TOC Reference Number: CRN 21-057A**Expiry Date:****31 January 2022****Distributed to:** Internal TOC Waiver Distribution List
External TOC Waiver Distribution List**Issued by:** Drew Palmer**Requested by:** Principal Track & Civil Engineer**Issued Date:** 22 September 2021**Start Date:** 26 September 2021

Subject: Reinstatement of alignment to Westdale

This TOC Waiver is updating the network configuration in the proximity of Westdale.

TRACK DIAGRAM - Werris Creek (excl) to Armidale (446km - 472km)

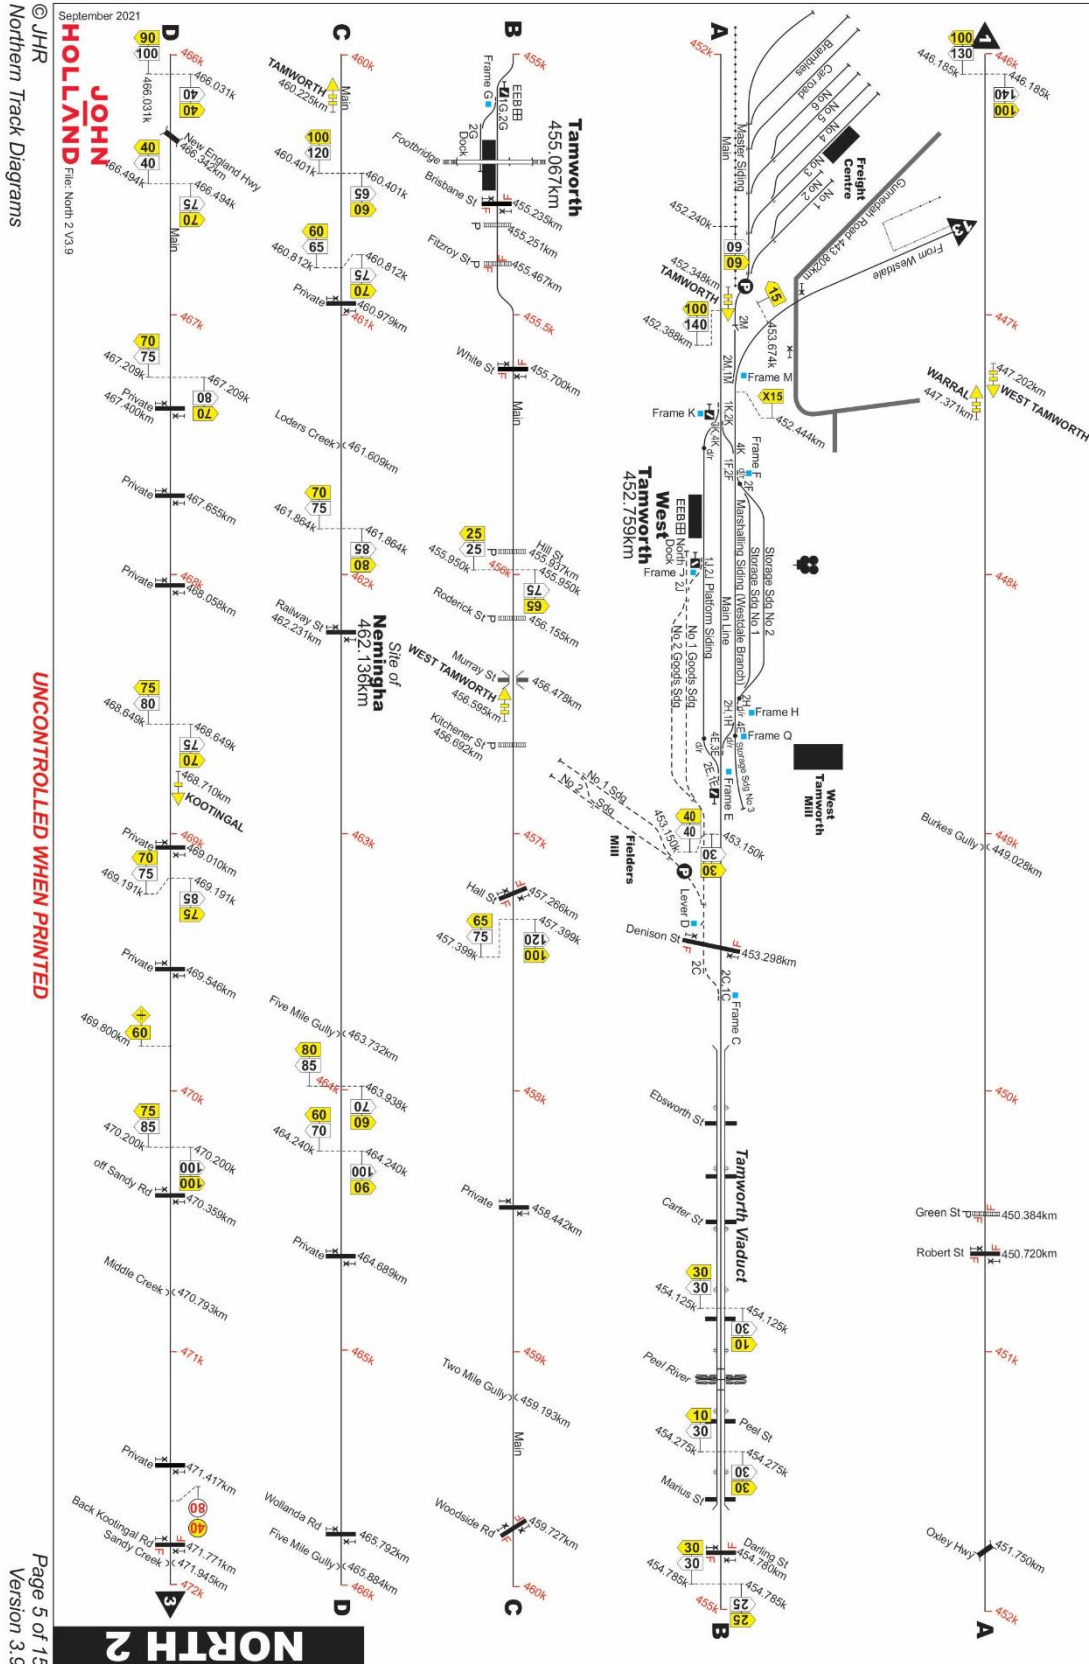
- Removal of the BP Siding
- Removal of the Joe While Maltings Sidings
- Removal of the Shell Depot Siding
- Removal of the Grain Siding
- Removal of the Mill Siding
- Removal of the Water Road
- Removal of Pedestrian level crossing at 452.548km
- Westdale alignment is reinstated
- Speed Board changes listed below:

Northern Section Diagrams – Werris Creek to Armidale

1. Km 452.444 DN Normal **X15 sign added**
